HIMACHAL PRADESH
PUBLIC WORKS DEPARTMENT

NO. PW-EE-RAJ-WA-FCA-Neri-Kotli Sanohat road /2025-26.

Diversion of 2.4657 hectare of Forest land in favor of Himachal Pradesh Public Works Department for C/O link road from Neri-Kotli, Sanohat to village Draina RD 0/0 TO 5/560, within the jurisdiction of Rajgarh Forest Division, Distt. Sirmour HP.

In reference to the proposal for FCA on the above cited subject. The FCA case is sent your office after attending the observation is as under :-

(D3)

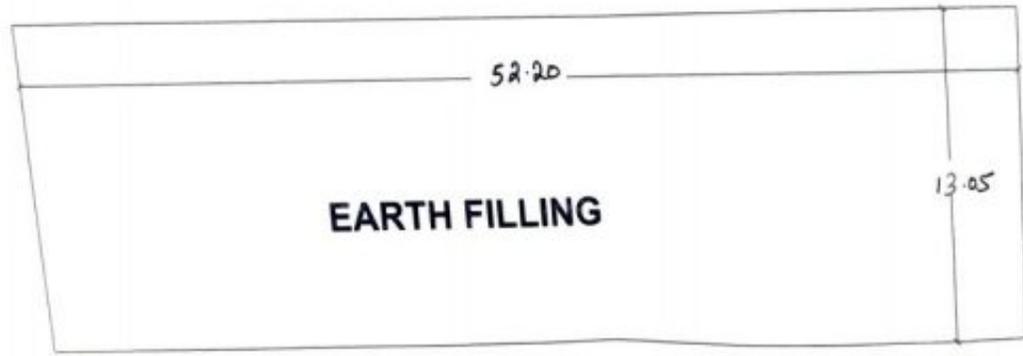
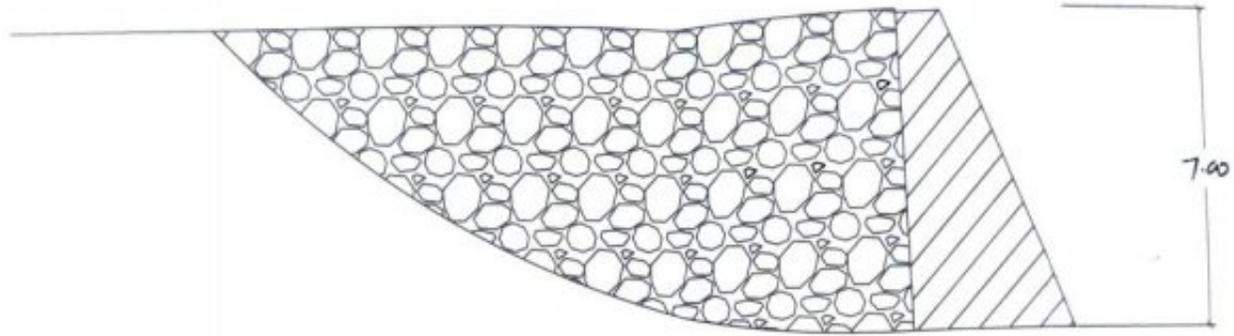
4	Dumping sites (03 No's) has been proposed in the forestland, therefore State Govt. may explore to shift the dumping sites to Non-forest land. Also, State Govt. may provide the list of Tree standing in the proposed dumping sites with photographs, if any and submit an undertaking with effect that No green standing Tree shall be felled in the dumping sites duly authenticated by DFO concerned.	Pertain to your office	
5	As per the KML and Muck Management Plan 3 dumping sites has been proposed however as per the S. No-B-2.4 only on consolidated dumping site has been mentioned. Therefore, State Govt. shall mark all the dumping sites with respective diversion	The correction has been made the same has been uploaded

L B H Qty
 84.10 14.50 7.00 = 8536.15 m³
